GE Nuclear Energy

ABWR

52-001

Subject IST Responses to telecon questions  
10/6 - For discussion 10/9

Table 3.9-8 (Continued)

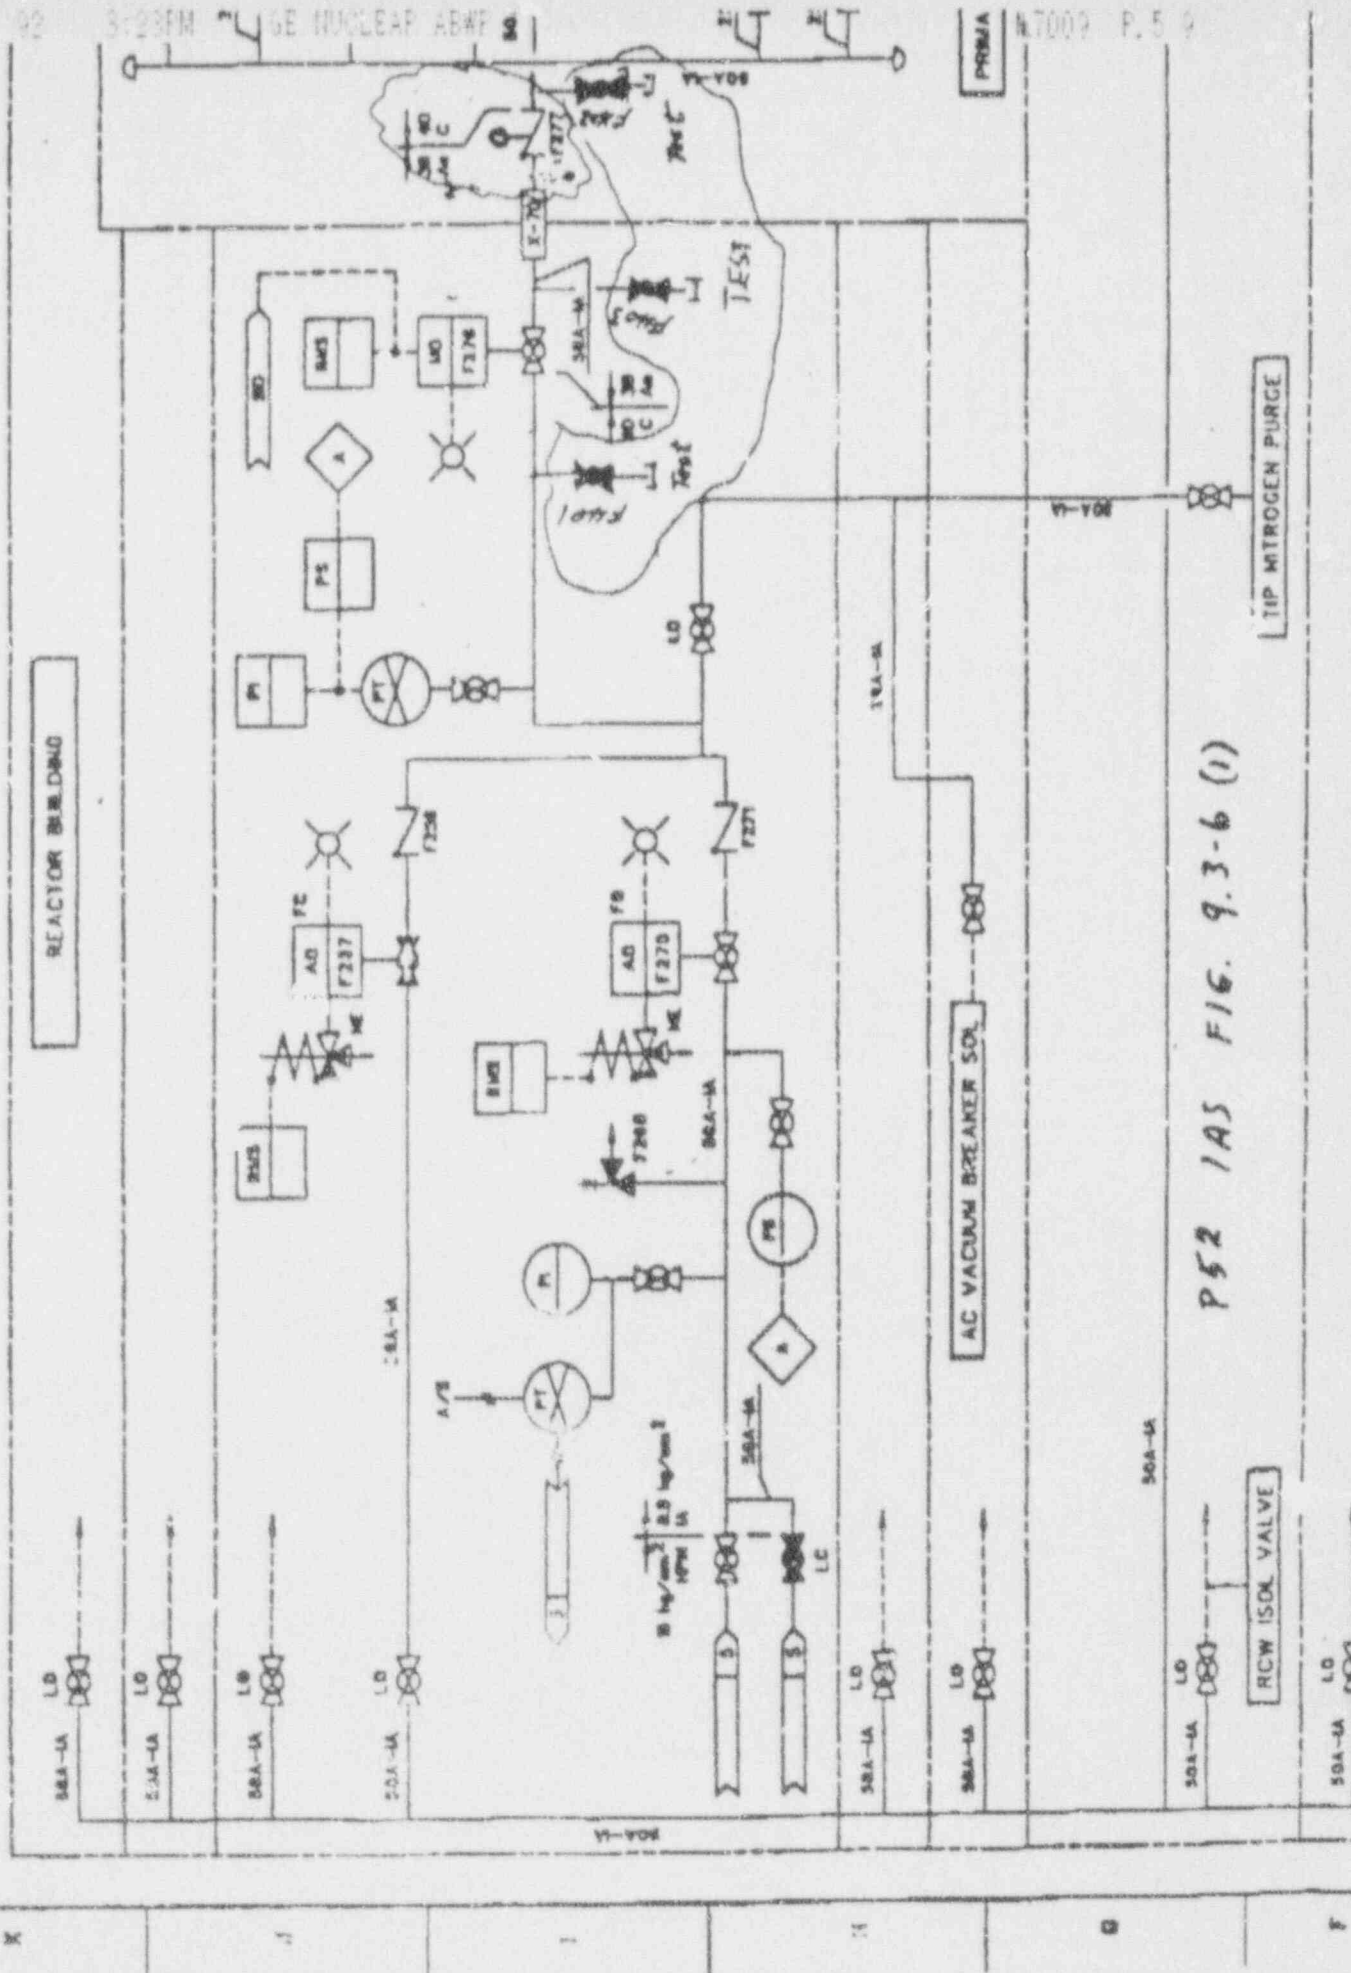
"The five year frequency for leak rate testing of the SRVs (F010) does not comply with ASME OM-10 which refers to OM-1. Table 1 of OM-1 requires that a minimum cumulative fraction of Class 1 pressure relief valves be tested during each 12 month period of a five year interval. Provide a technical justification for the test frequency presented in Table 3.9-8 for the SRVs."

Note (1) in Table 1 in American Society of Mechanical Engineers (ASME) ~~OM-1~~ states: *Part 1*

"(1) No maximum limit is specified for valve tests within any specific time period of the above table; however, a minimum of 20% of the valves of each type and manufacture shall be tested within any 24 months. This 20% shall be previously untested valves, if they exist."

The five year interval identified in Table 3.9-8 in the United States (US) Advanced Boiling Water Reactor (ABWR) Safety Analysis Report (SSAR) is selected to meet the testing requirements of ASME OM-1, Section 1.3.3.1, Paragraphs (a) and (b).

The test frequency for testing SRVs provided in Table 3.9-8 in the US ABWR SSAR is in accordance with the In-Service Tests for Category C valves specified in ASME OM-10, Paragraph 4.3.1. Specifically, periodic testing of SRVs will be in accordance with Paragraph 3.3.1 of ASME OM-1 for the appropriate test event.
